From: Kristen Kapelanski, AICP  
Date: 12/5/2017  
Re: **Premier Academy (City File #17-018)**  
**Site Plan – Planning Review #3**

From: Craig McEwen, Building Inspector/Plan Reviewer *CPM*  
To: Sara, Roediger, Planning Department  
Date: November 17, 2017  
Re: Premier Academy Oakland, LLC – Review #3  
Adams & Tienken  
Sidwell: 15-08-100-021 and 22  
City File: 17-018

JB  
From: Jason Boughton, AC, Engineering Utilities Coordinator  
To: Kristen Kapelanski, AICP, Manager of Planning & Development  
Date: December 6, 2017  
Re: Premier Academy Oakland, City File #17-018, Section 8  
Site Plan Review #3

From: Michael Taunt, Survey Technician *MT*  
To: Sara Roediger, AICP, Director of Planning & Development  
Date: December 7, 2017  
Re: Premier Academy LLC, Section 8, City File #17-018  
Review #3 - Comments for Revised Site Plan

**CITY OF ROCHESTER HILLS**  
 STANDARD DETAIL FOR:  
**Sight Distance Roadways**

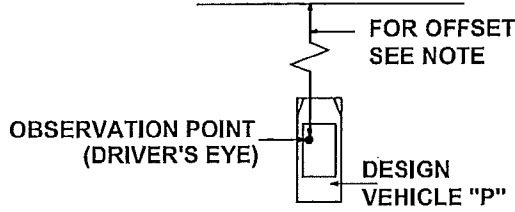
1. Coordinate with the RCOC regarding potential Tienken Road center turn lane extension to the east.
2. The City requests the master ROW is dedicated to RCOC. The city will help facilitate processing the dedication.
3. On the Landscape Plan, show the road sight distance lines at Adams and Tienken Rd driveway approaches per the attached detail.
4. Provide a "pork chop" island at the right-in, right-out only driveway to Adams Road.
5. Please reference attached letter from RCOC to clarify their stance on road improvement requirements for this development.

CITY OF ROCHESTER HILLS  
STANDARD DETAIL FOR:  
Sight Distance Pathways

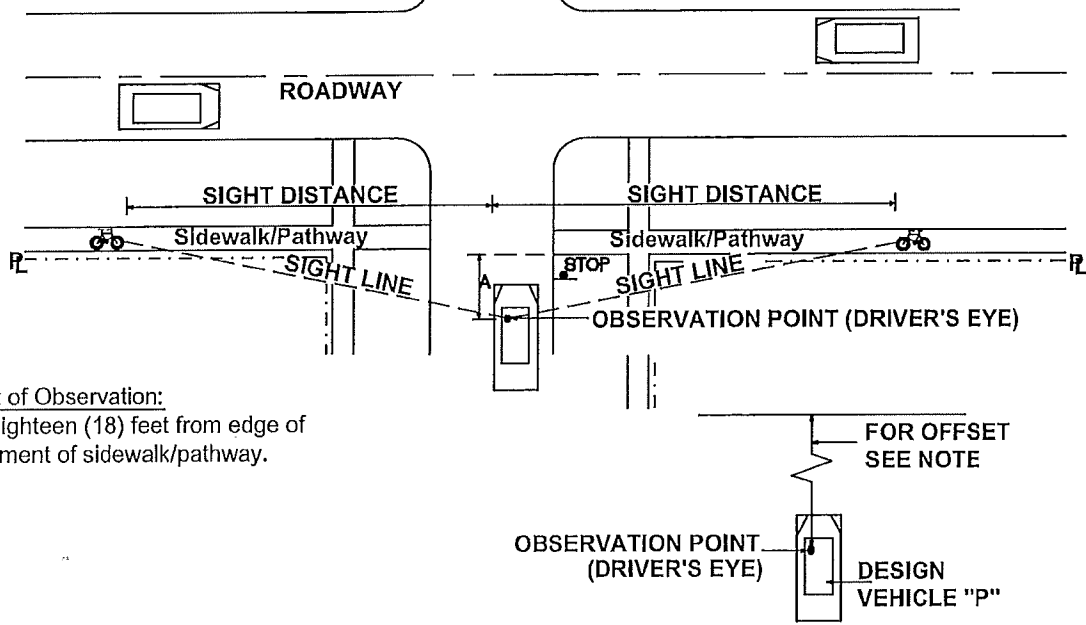
1. Show on the landscape plan the pathway sight distance lines at Adams and Tienken Rd driveway approaches per the attached detail.
